**CITY OF SEATTLE
ANALYSIS AND DECISION OF THE DIRECTOR
OF THE DEPARTMENT OF PLANNING AND DEVELOPMENT**

Application Number: 2107947
Applicant Name: Steve Lampert, Project Architect
Address of Proposal: 424 North 85th Street

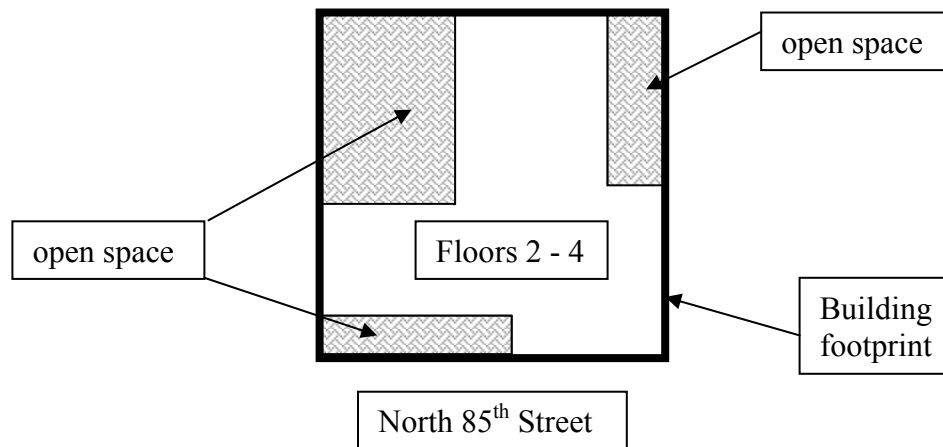
The Board noted that massing of the building is critical to the overall success of the project design. The architect should consider centering the mass of the building on the site which would provide relief to the streetscape below as the building would not present a flat four story facade adjacent to the rights-of-way. A portion of the building could be brought out to the southeast corner at the intersection of Dayton Ave N and N 85th Street because it is such a prominent corner. An example, but in no means the only solution, of the building massing is:
